TO: City Council
FROM: City Manager and Staff 
DATE: September 13, 2007
SUBJECT: Proposed Non-motorized Intersection Improvements at Forum Boulevard and Stadium Boulevard

Subject: Columbia Non-Motorized Pilot Program Intersection Designs
Stadium Boulevard and Forum Boulevard
City Project Nos. NMT 2006-0001
Federal Aid Project No. CPP-9999(502)
Response to a Letter of Inquiry

RE: Review of Preliminary Plans of Stadium and Forum Intersection

Re: Columbia, Missouri NMT Intersections – CPP 9999(502)

STADIUM BLVD. & PROVIDENCE RD. PLAN

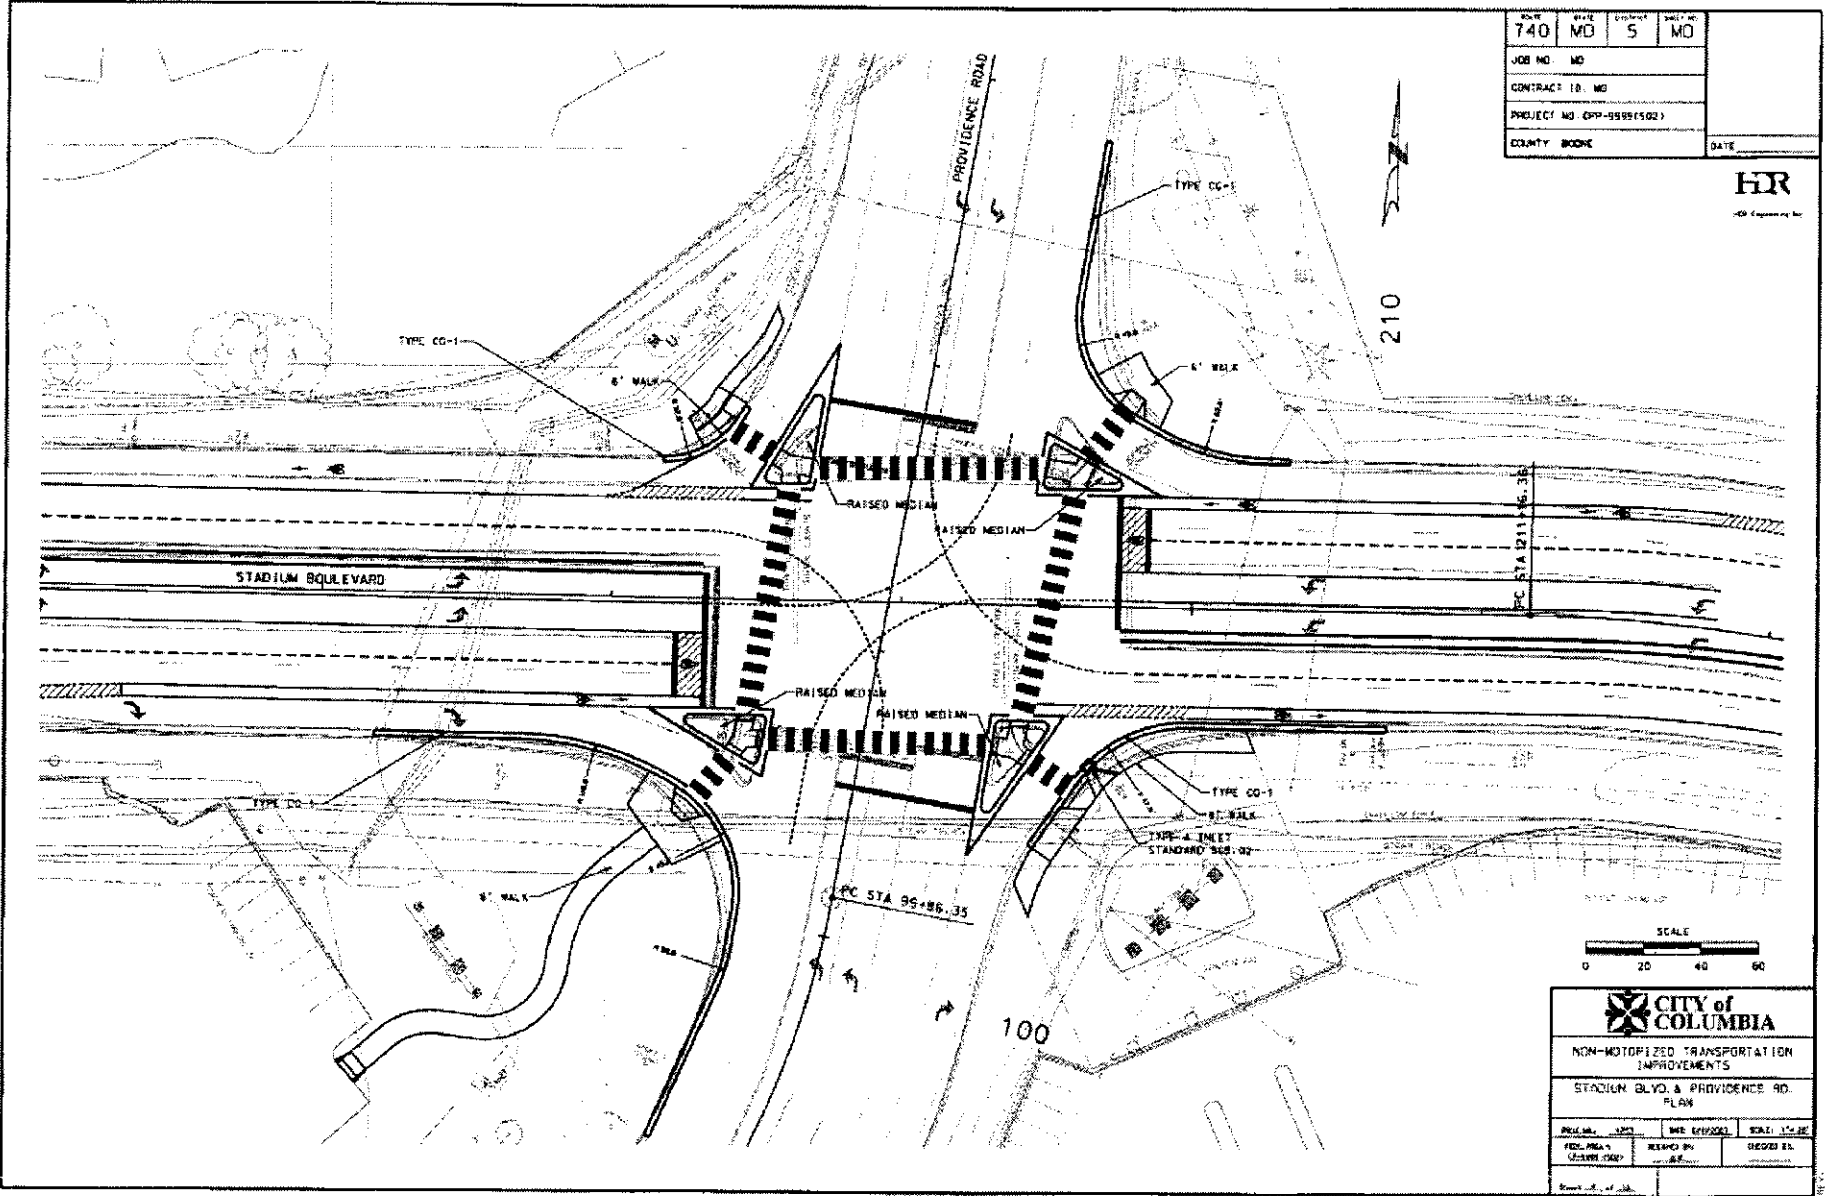
1. Per discussion since submittal, eliminate bicycle boxes.
2. Will there be loops for the bicycle lanes?
3. Tie points for sidewalks and bicycle lanes east of intersection may need to be adjusted. Examination will be part of a future engineering project.
4. There will need to be water service conduit to all landscape islands.

FORUM BOULEVARD
Forum

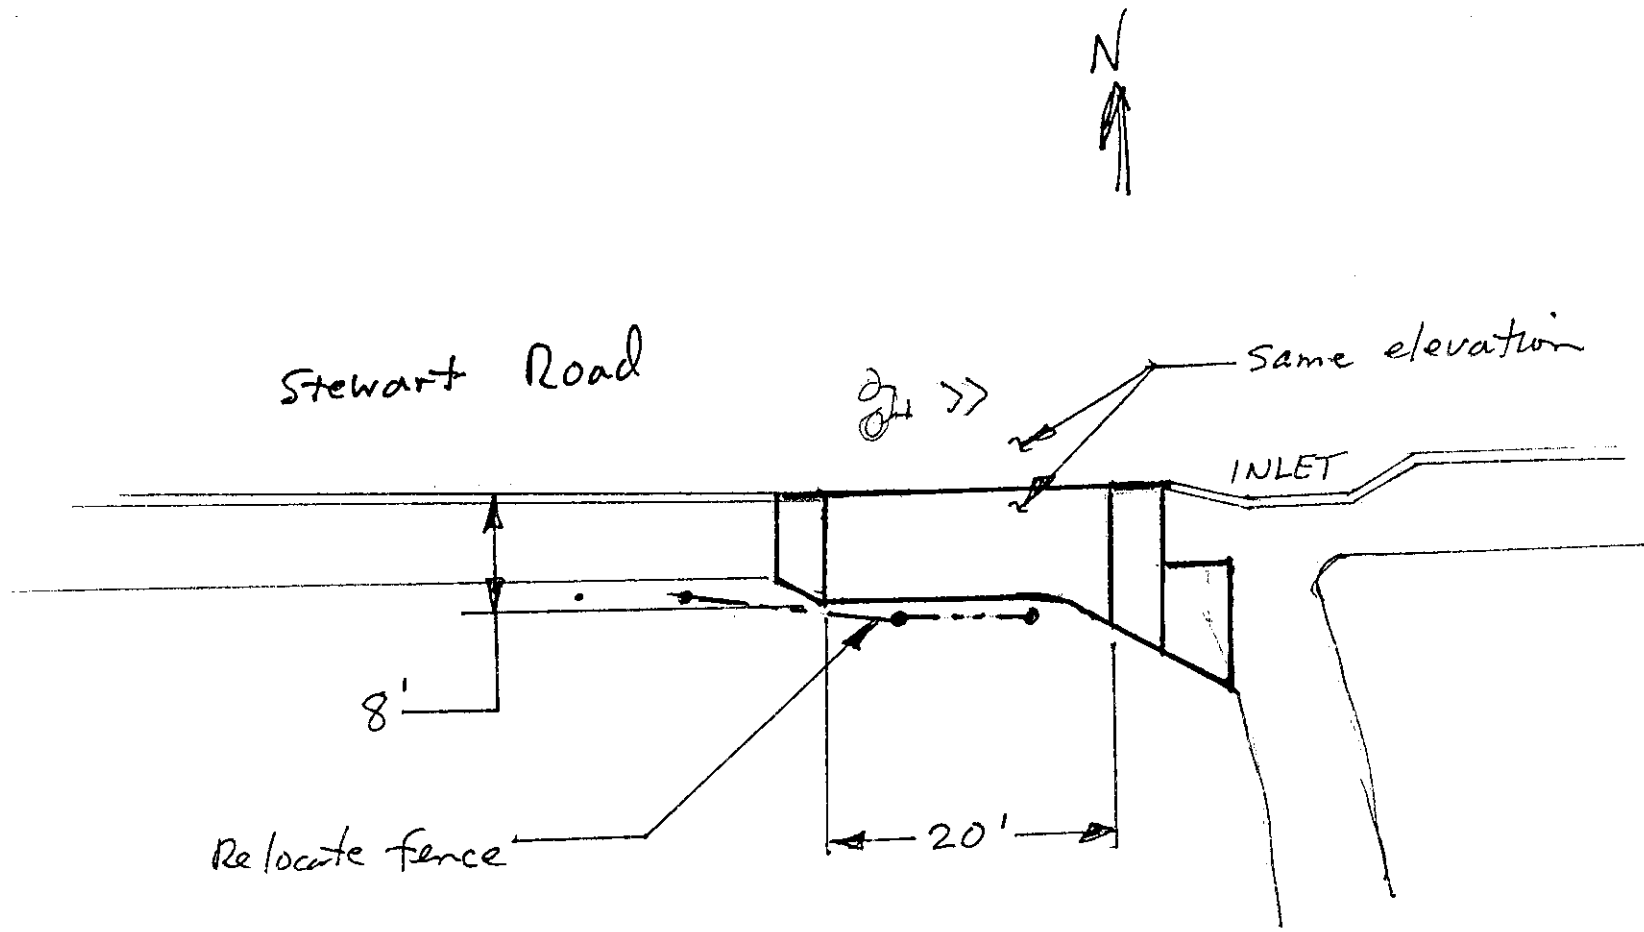
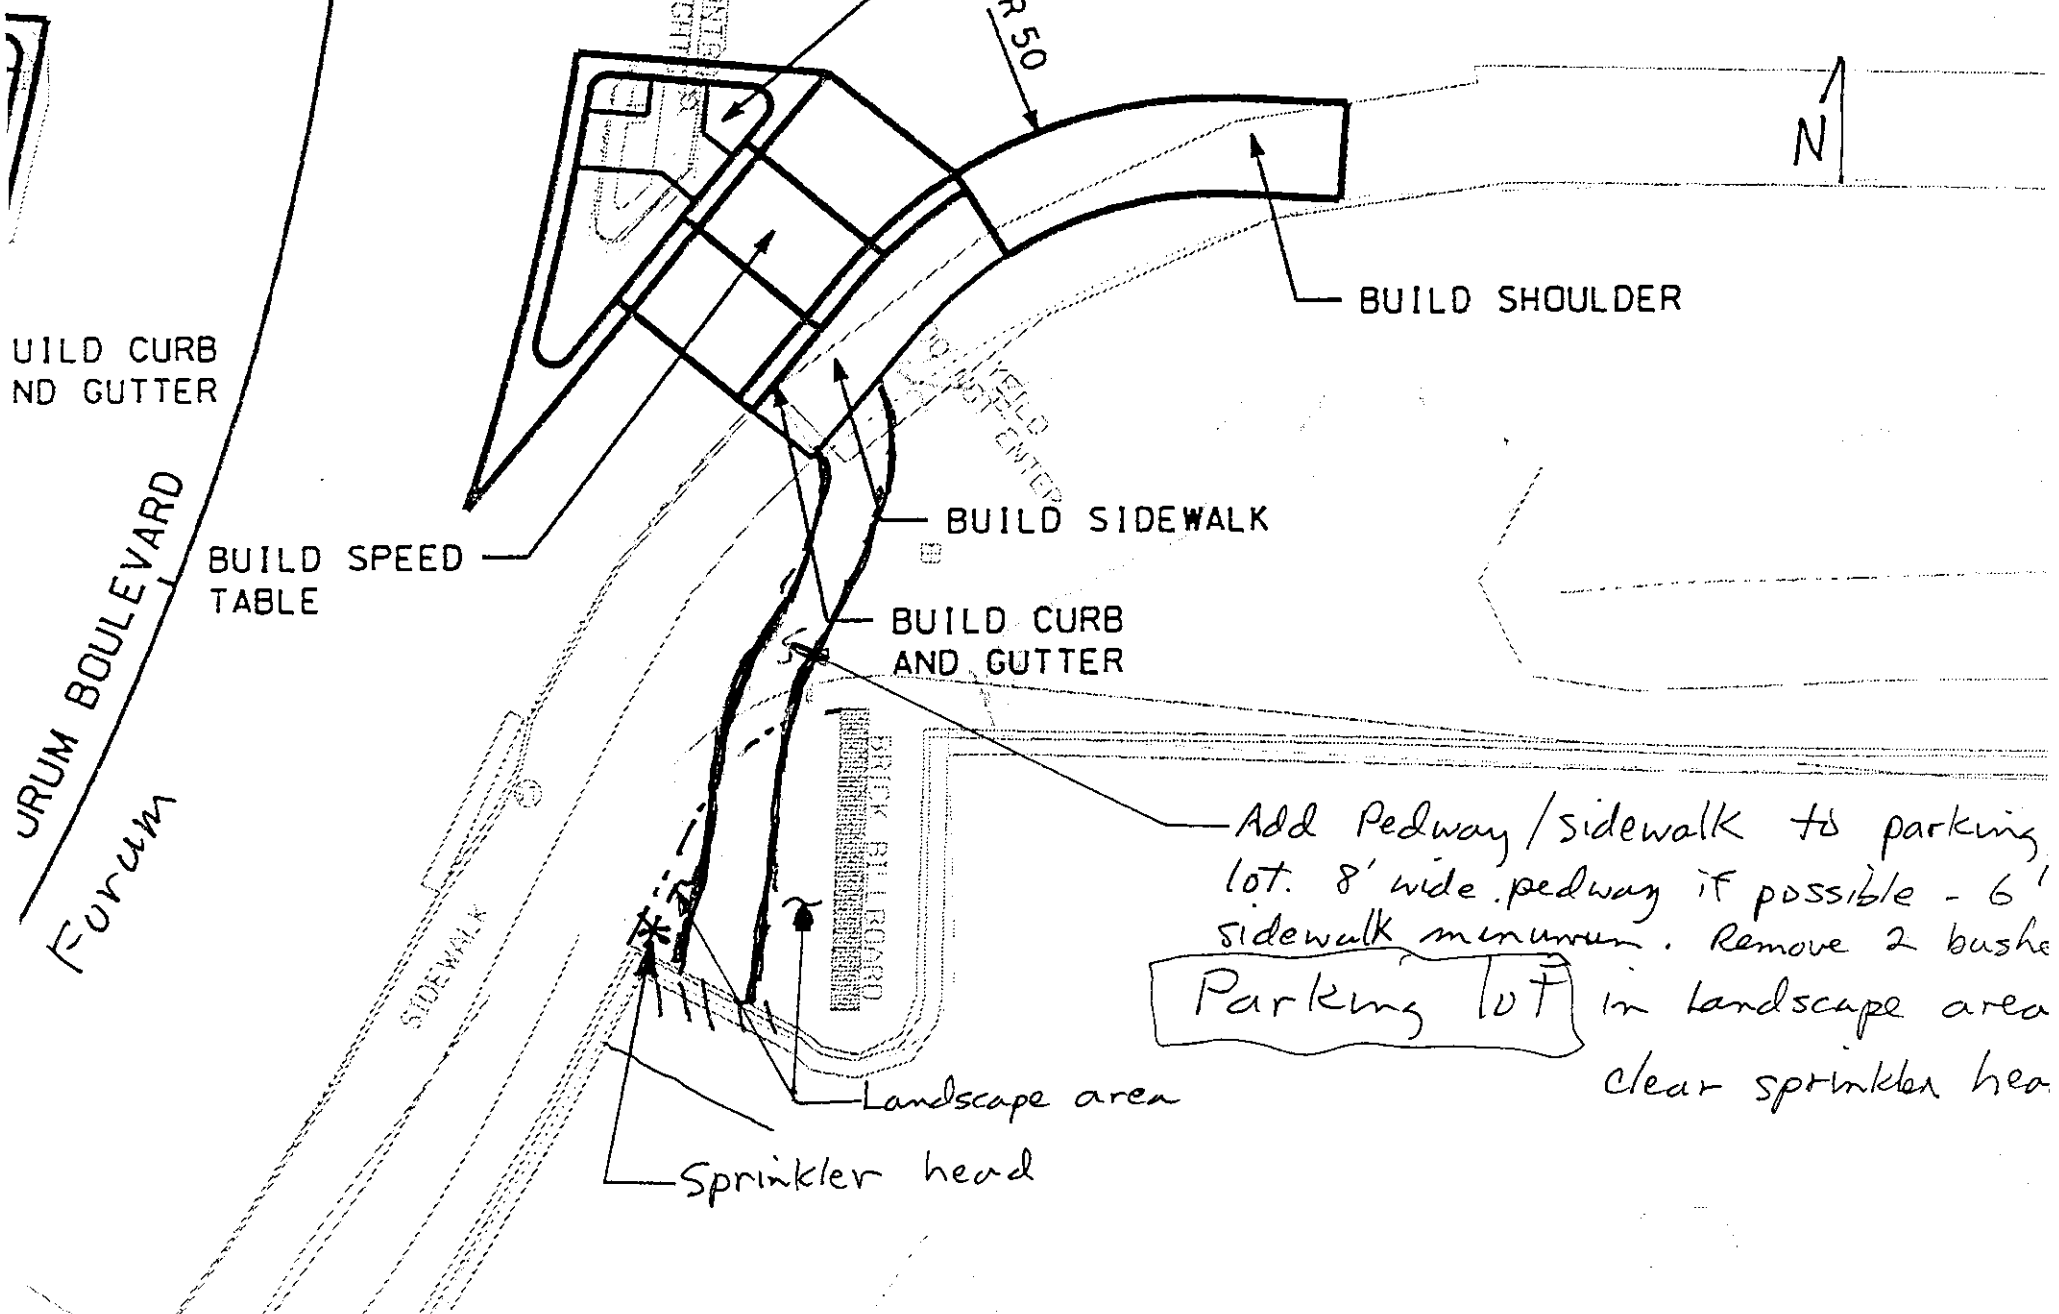
3. Recommend that the location of the flat area be a minimum of one car length from Stadium. Additional interior opening for cycle turning desirable. Sketch of proposed set-up attached.

6. Add a 8' sidewalk connection from the sidewalk on the SW corner to the Schnucks parking lot, connecting to one or two spaces. Attached is a sketch of the general layout as discussed with the adjacent property owner. Adjustments for grades may be necessary to accommodate ADA requirements. Will need to be labeled as 'Not part of this project' due to acquisition time line.

SHIFT TABLE PORTION ~1/3'
SOUTH - PROVIDE 1 CAR LENGTH
FROM RAISED FLAT AREA TO
NOSE OF ISLAND

Expand bike-ped crossing area to minimize conflicts.

Add Pedway/sidewalk to parking
lot. 8' wide pedway if possible - 6'
sidewalk minimum. Remove 2 bushes
